RE: Hydrogen Energy California Project  
Application for Certification 08-AFC-8

# Responses to CEC Data Requests Set Two (Nos. 133 through 152)

## Revised Application for Certification (08-AFC-8) for HYDROGEN ENERGY CALIFORNIA Kern County, California

T:\PROJECTS\Hecam\Biology\Assessment\_011910\Vegetation Community\F2.mxd - 1/25/2010 @ 9:19:27 AM

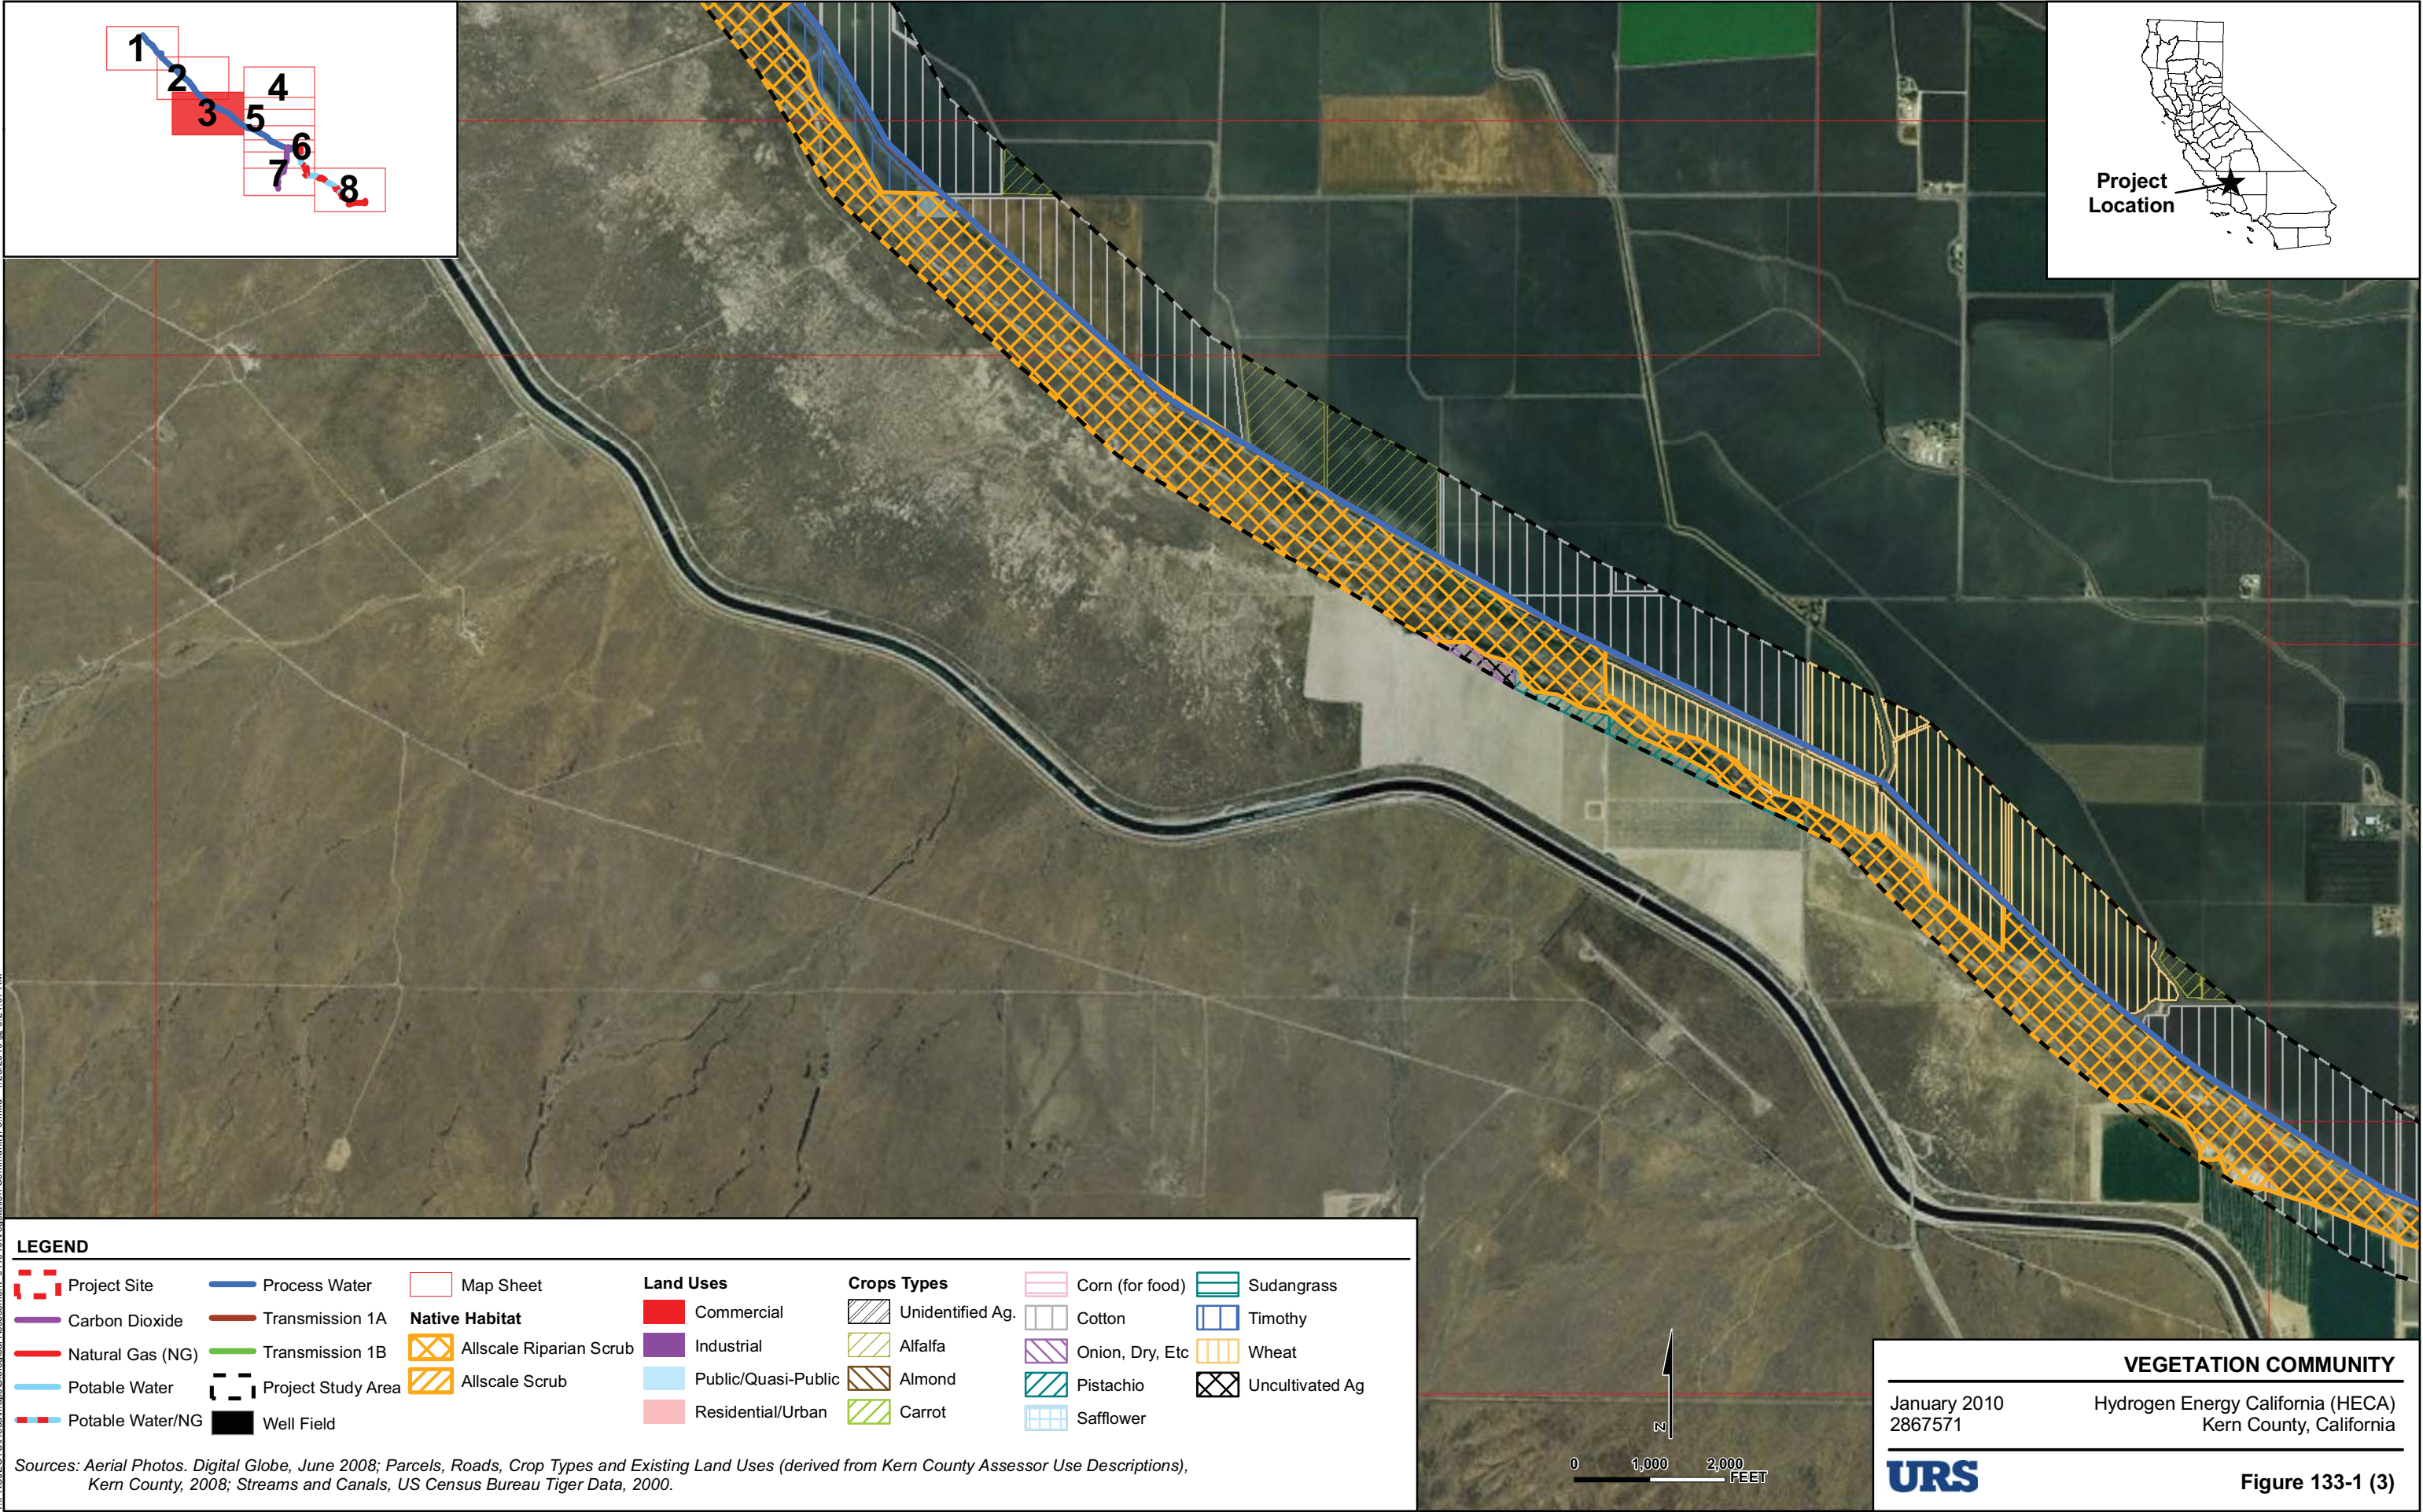
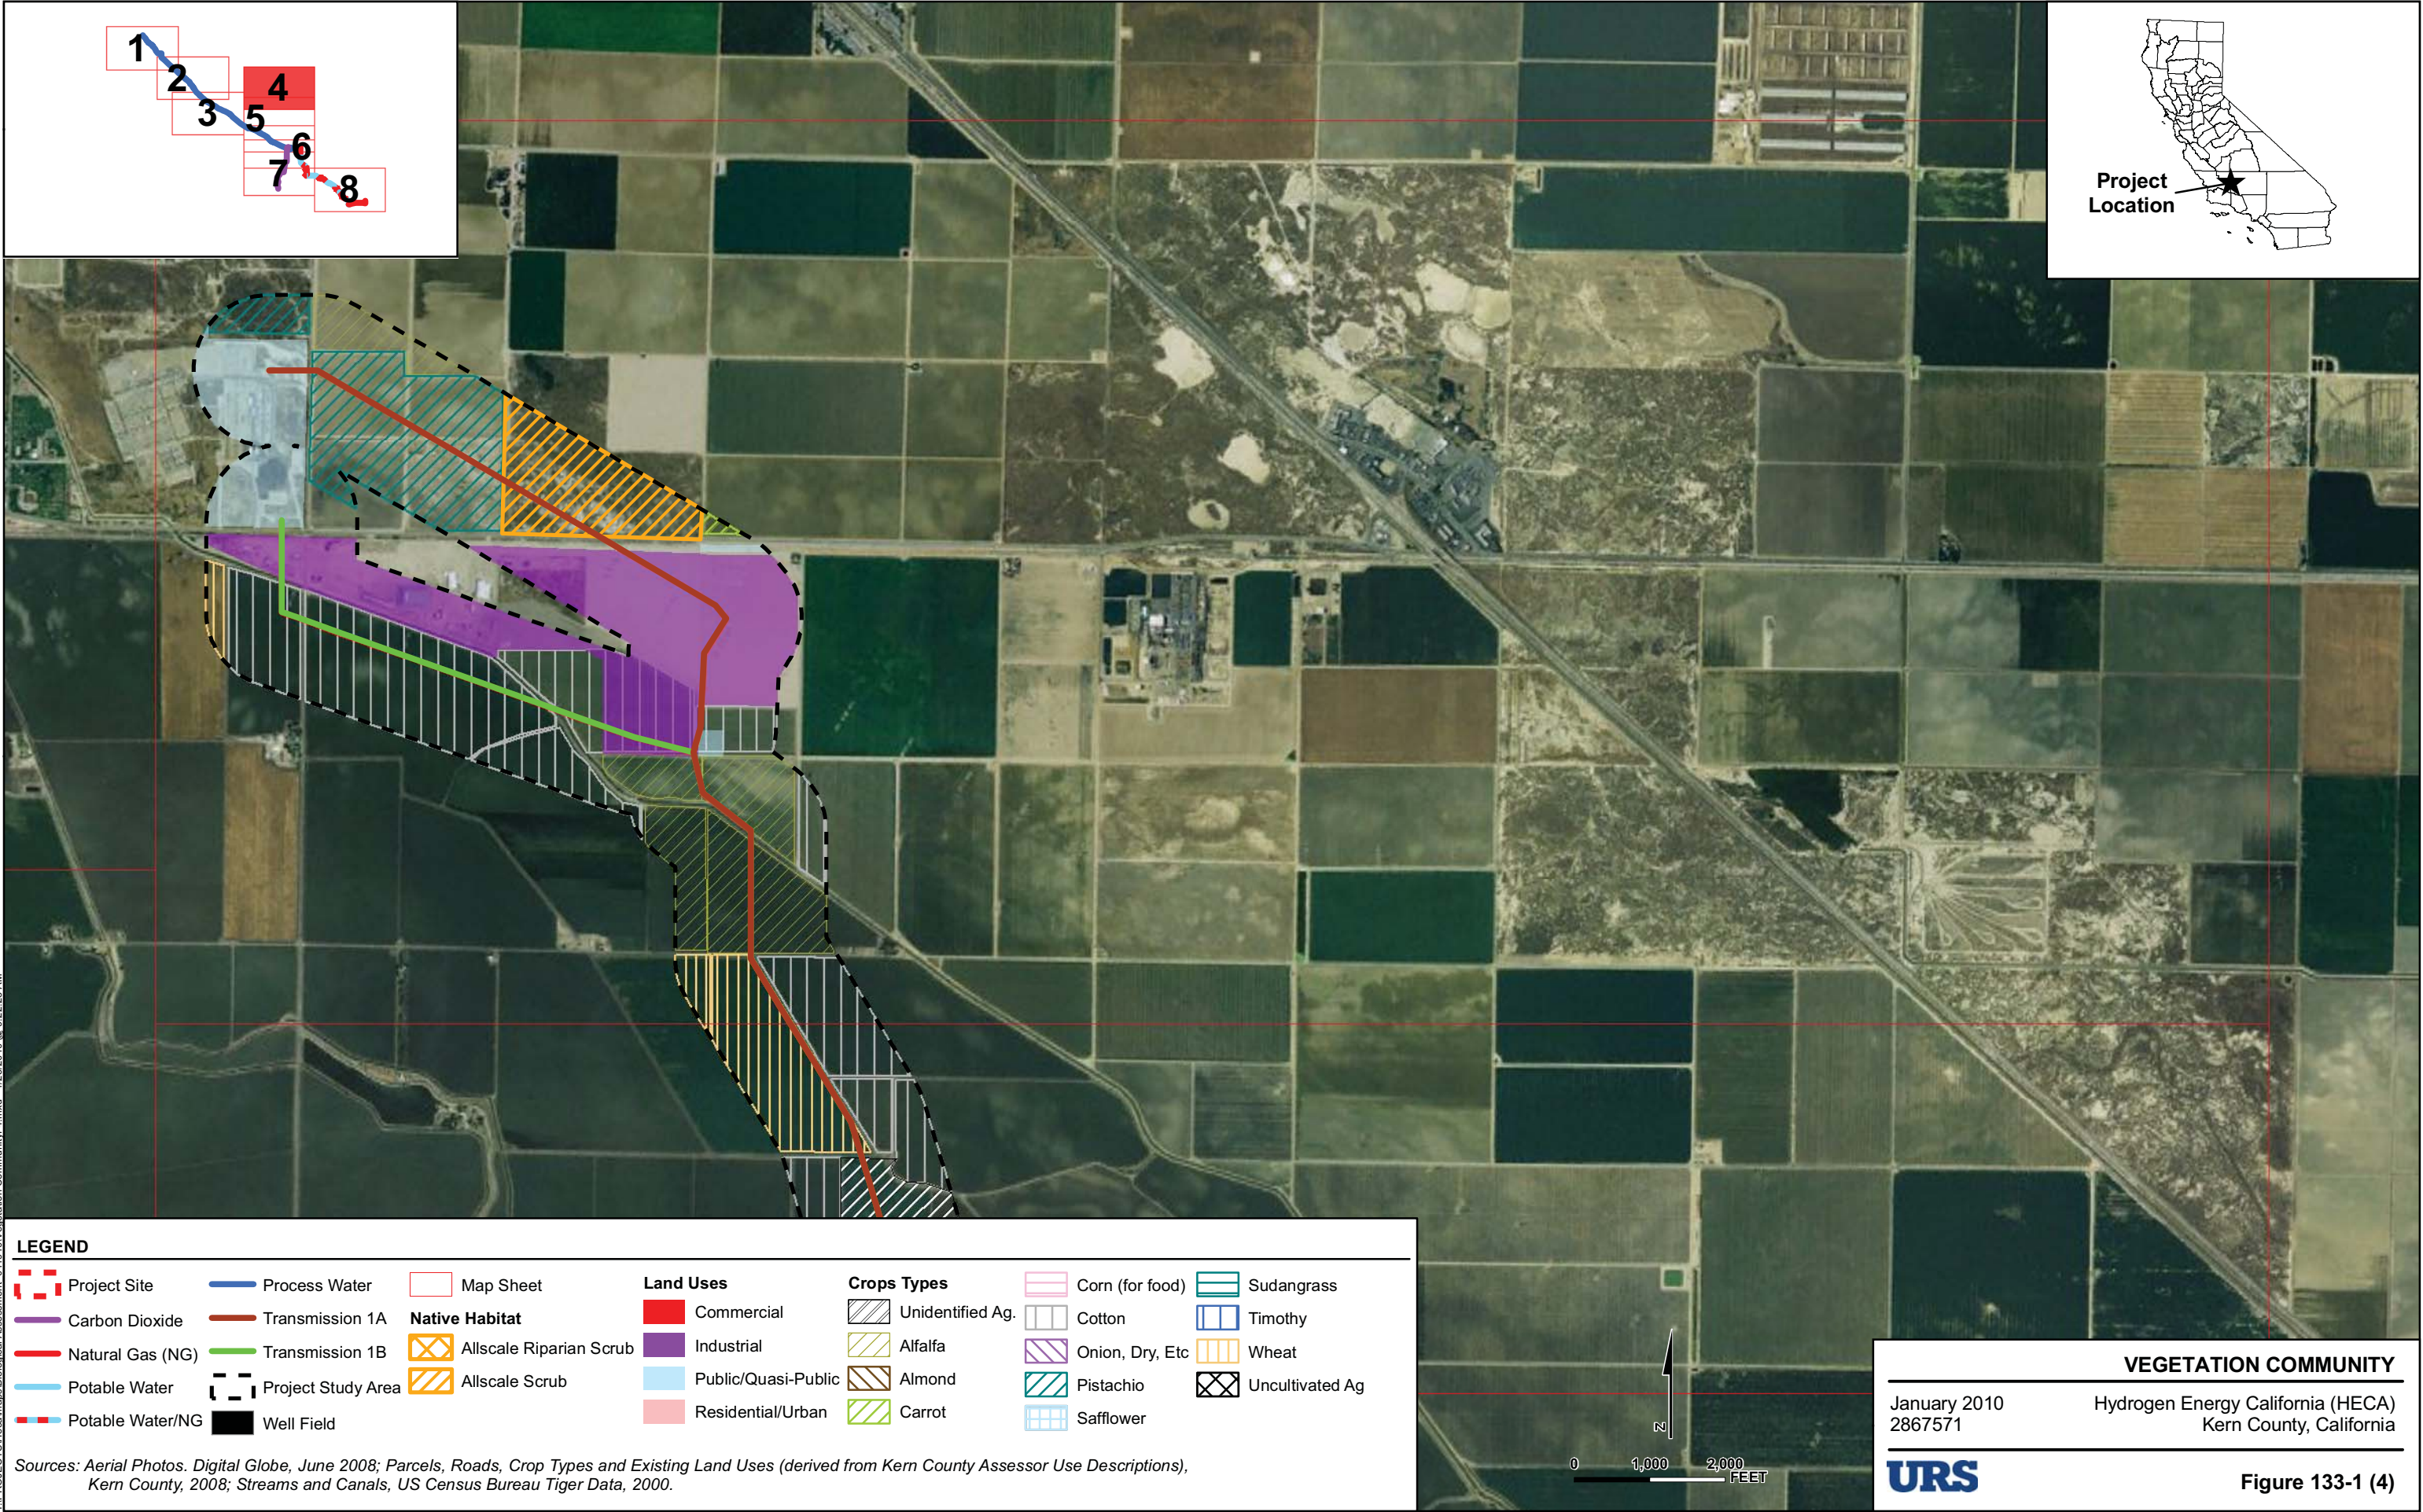
- 133. *Please provide a vegetation community map for the Biological Resources Study Area shown on Figure 5.2-1 in the Revised AFC. If possible, please prepare this figure at a scale of approximately 1:2,000 feet on a current aerial photograph. The vegetation community map must show the project site, all project linear facilities, and the broader study area that was surveyed as part of the Biological Resources Study Area of the Revised AFC.***

Figure 133-1 presents a vegetation community map for the Biological Resources Study Area that was referred to in the Revised Application for Certification (AFC). The figure has been prepared at the requested scale on an aerial base.
